Limerick Generating Station, Units 1 and 2
Facility Operating License Nos. NPF-39 and NPF-85
NRC Docket Nos. 50-352 and 50-353

Subject: Response to Request for Additional Information Concerning Relief
Requests Associated with the Second Inservice Inspection (ISI) Interval

**Response to Request for Additional Information
Regarding Relief Requests Associated With the
Second Inservice Inspection Interval**

Limerick Generating Station, Units 1 and 2

Limerick Unit-1 Recirc Inlet - N2J

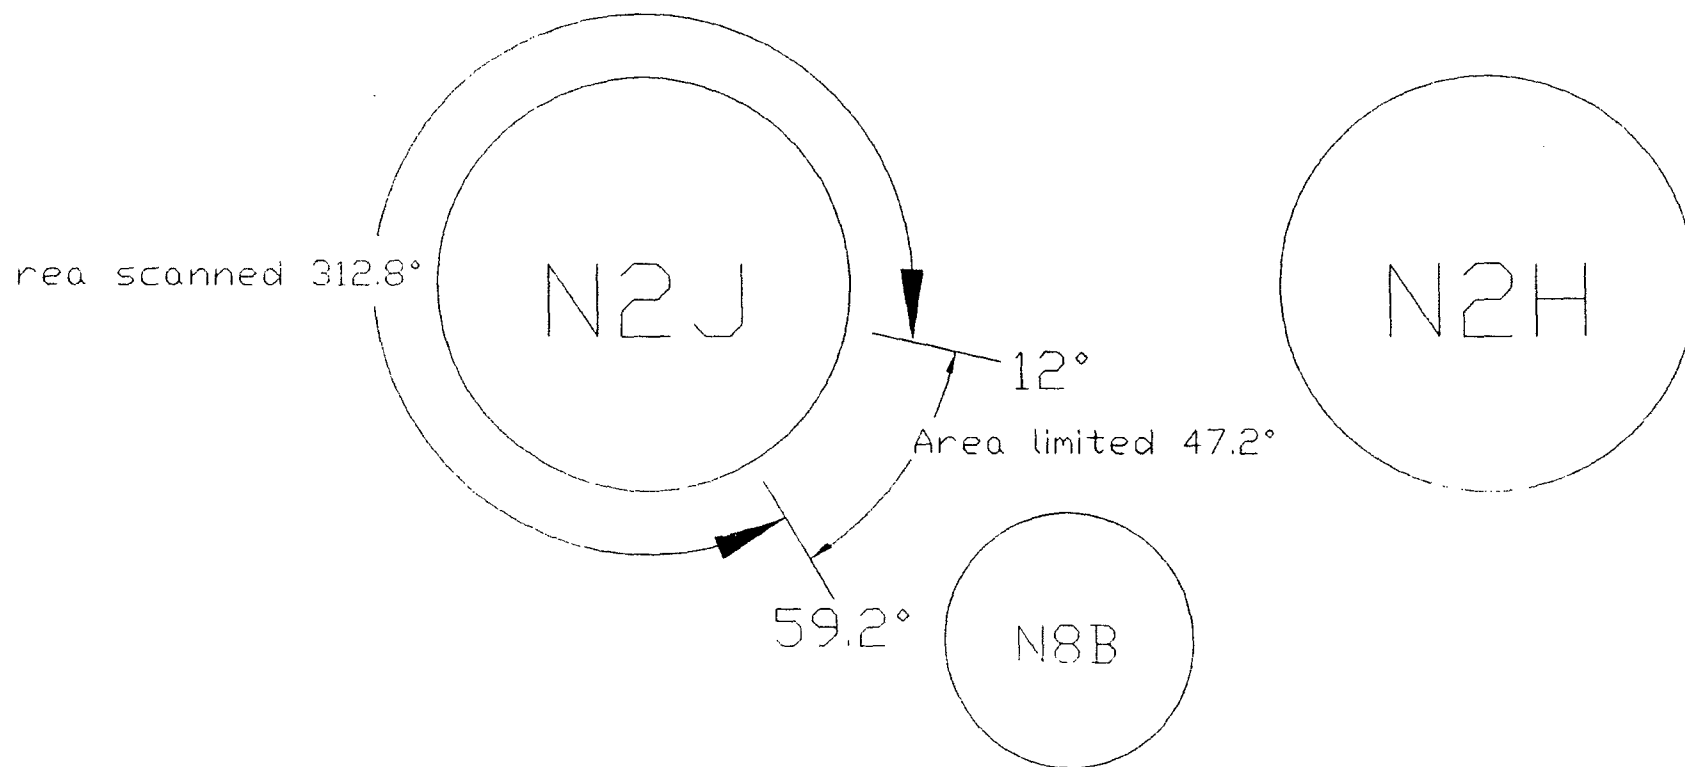
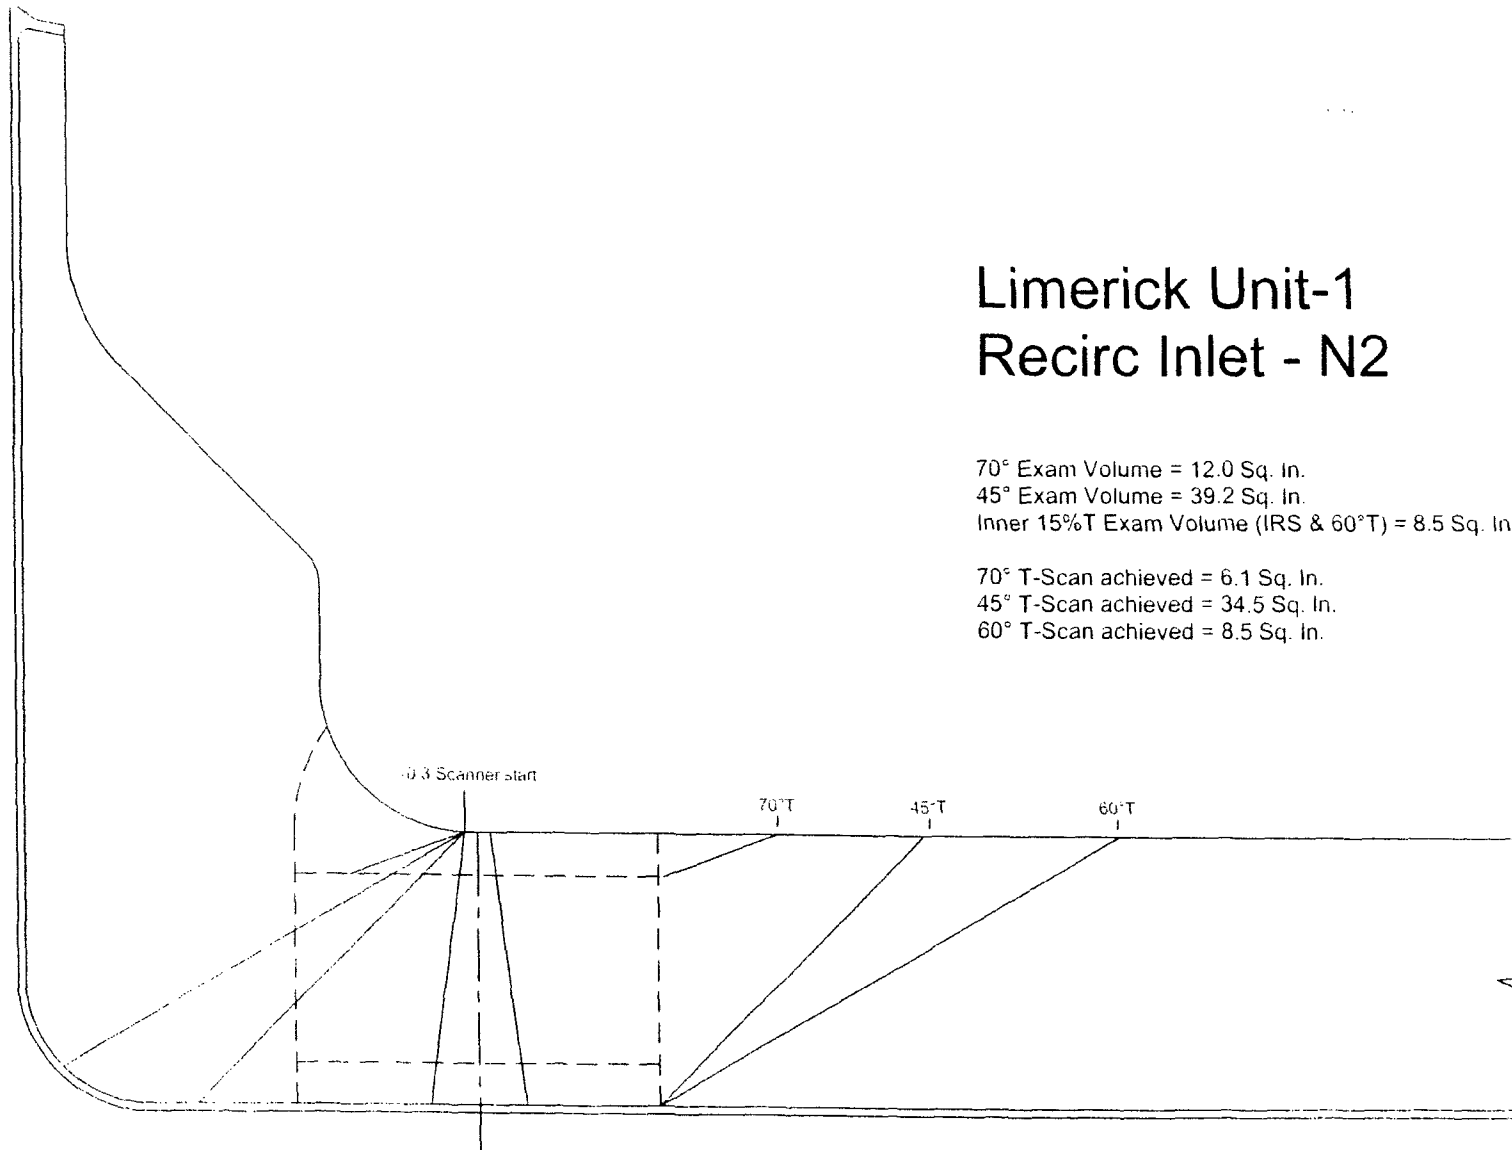
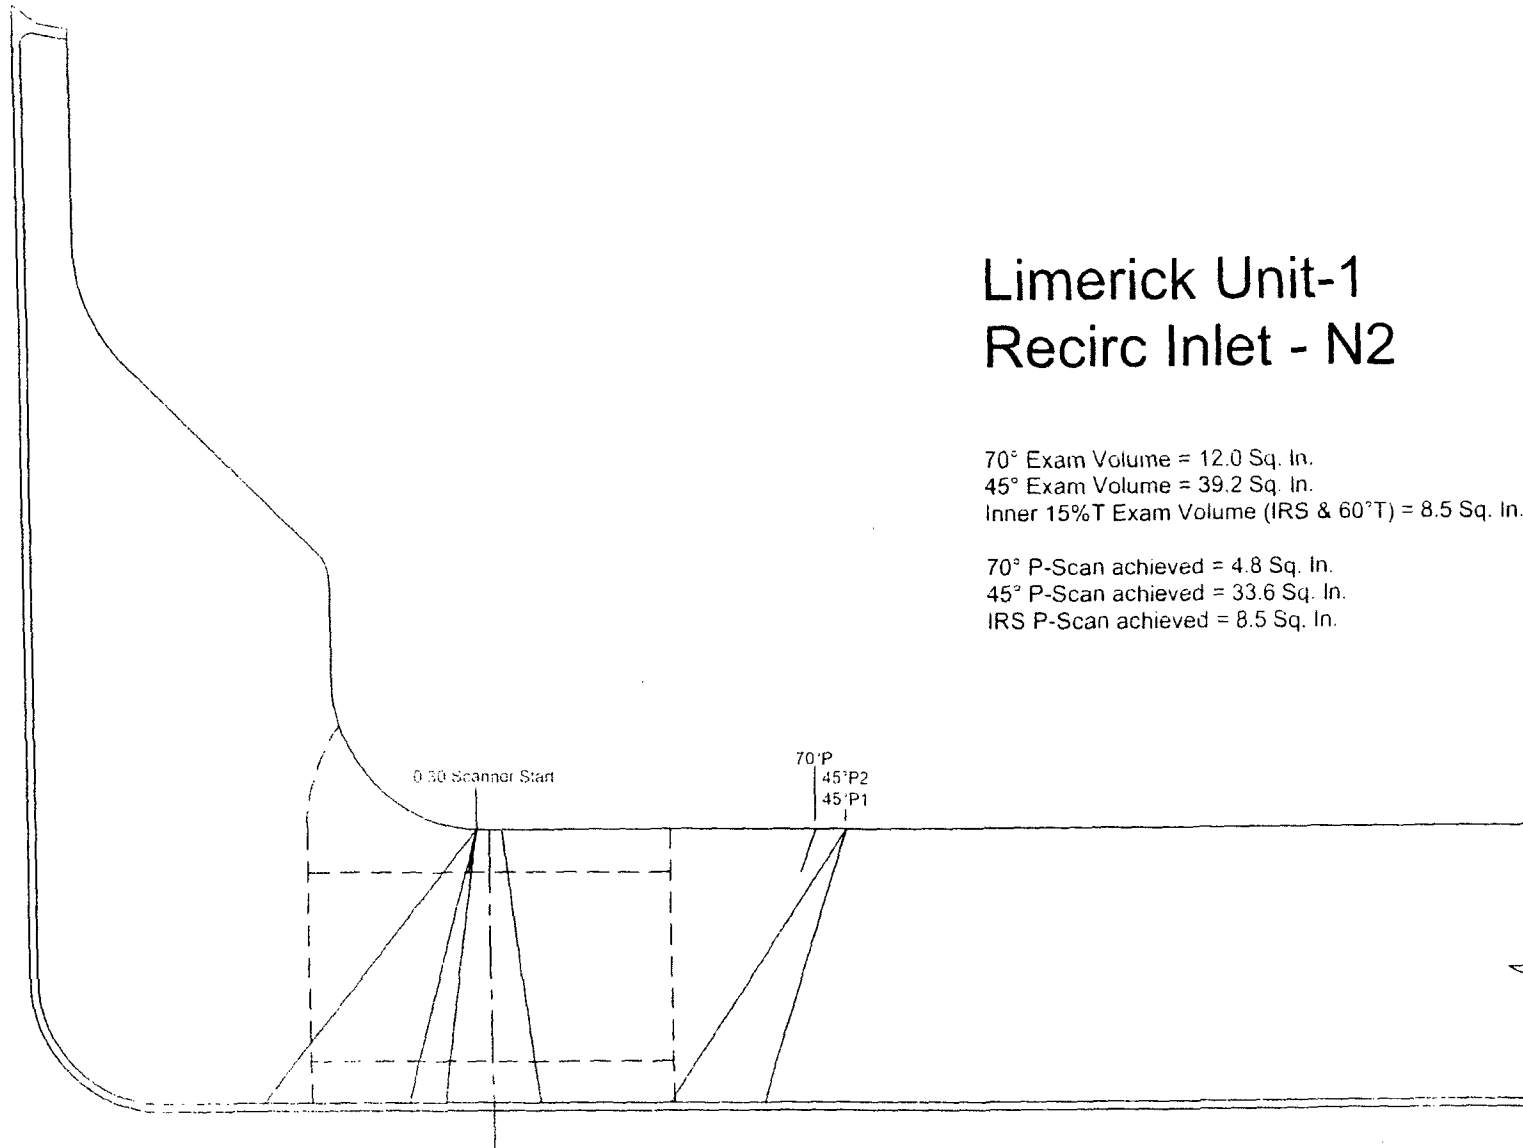
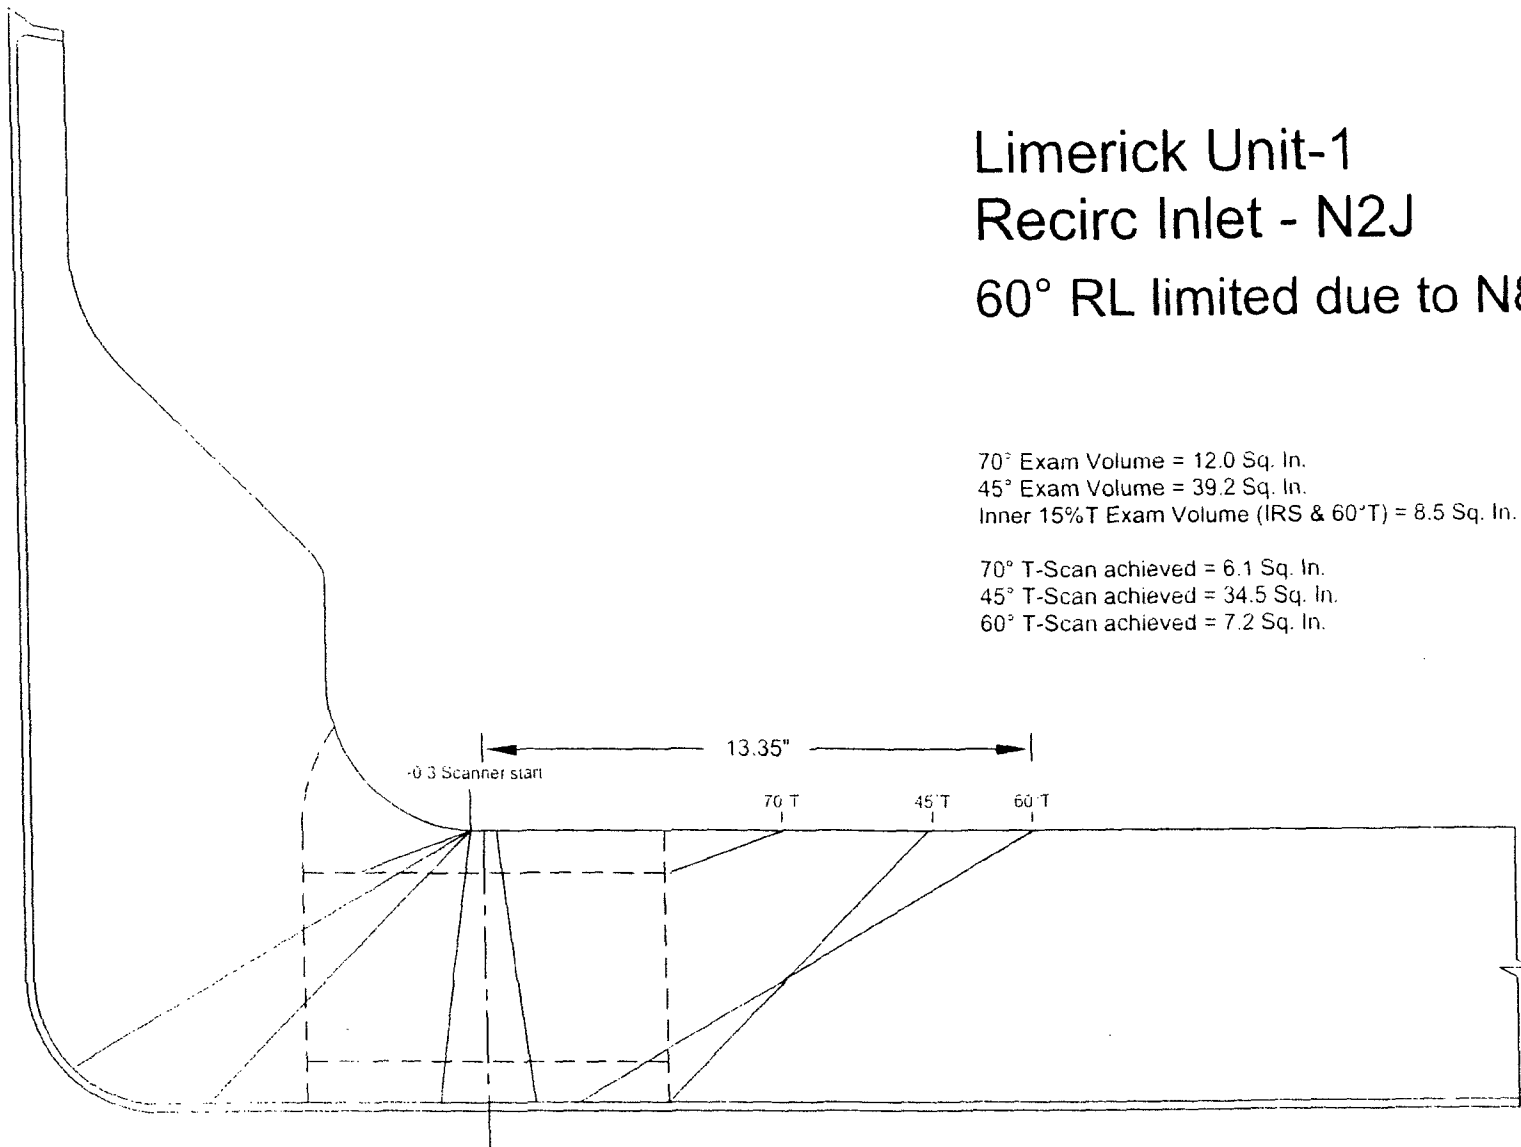
The completed examination was limited to 77.0% Code required coverage due to the design of the reactor vessel nozzle and the location of the N8B nozzle. The following coverage calculation sheet and the drawings contain the limitations. No unacceptable indications were noted. A system pressure test was also completed with no unacceptable indications observed.

Comments: A - Scanned 360 deg., Scanning limited due to nozzle configuration.
B - 60°RL limited due to the proximity of the N8B nozzle.

60° RL limited due to proximity of N8B nozzle

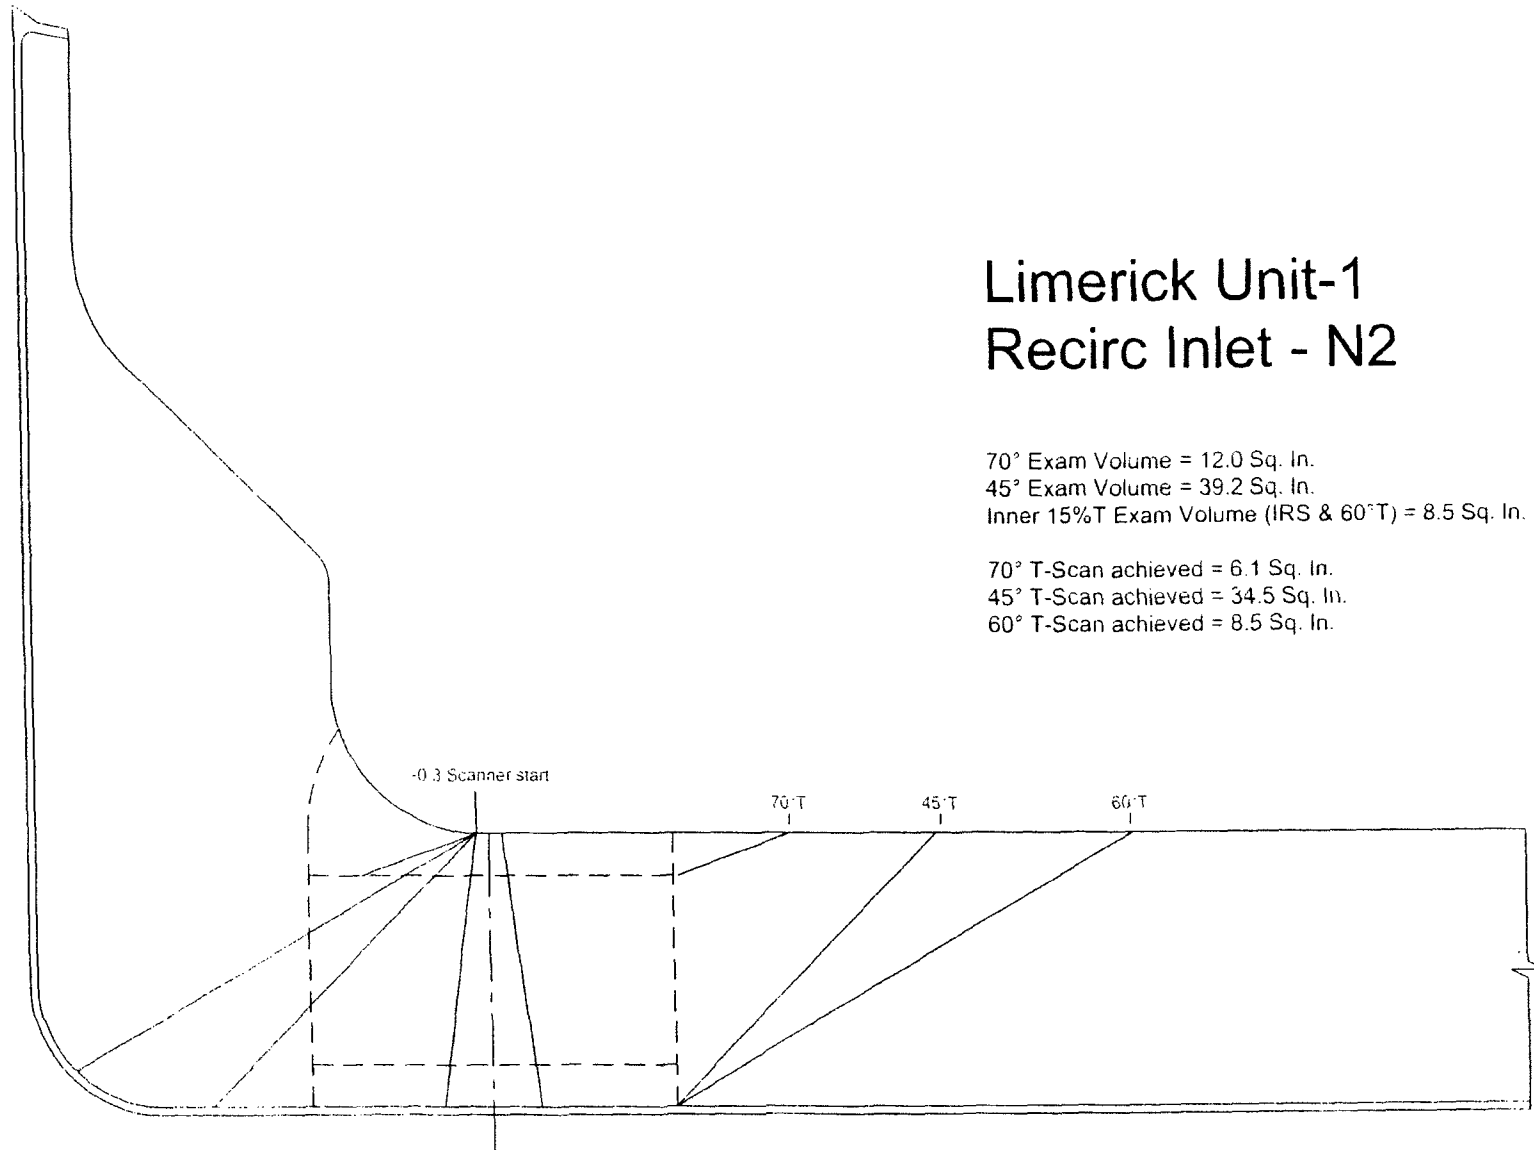
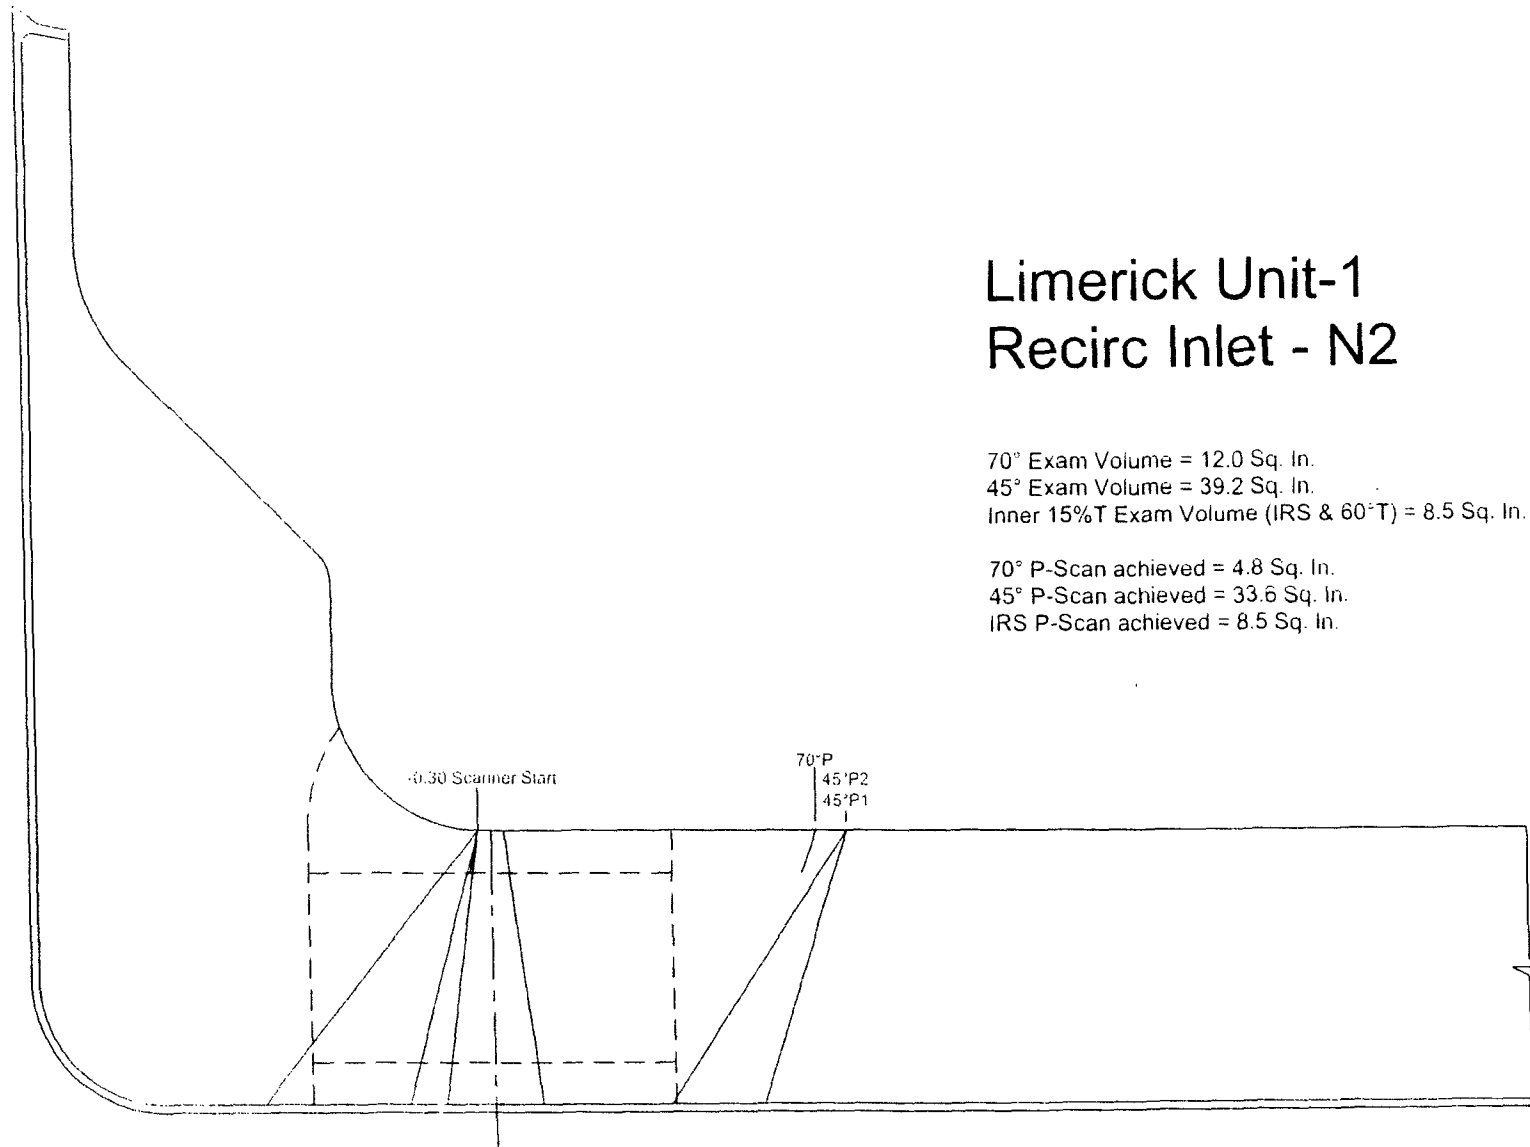
The completed examination was limited to 80.4% Code required coverage due to the design of the reactor vessel nozzle. The following coverage calculation sheet and the drawings contain the limitations. No unacceptable indications were noted. A system pressure test was also completed with no unacceptable indications observed.

Comments: A - Scanned 360 deg., Scanning limited due to nozzle configuration.
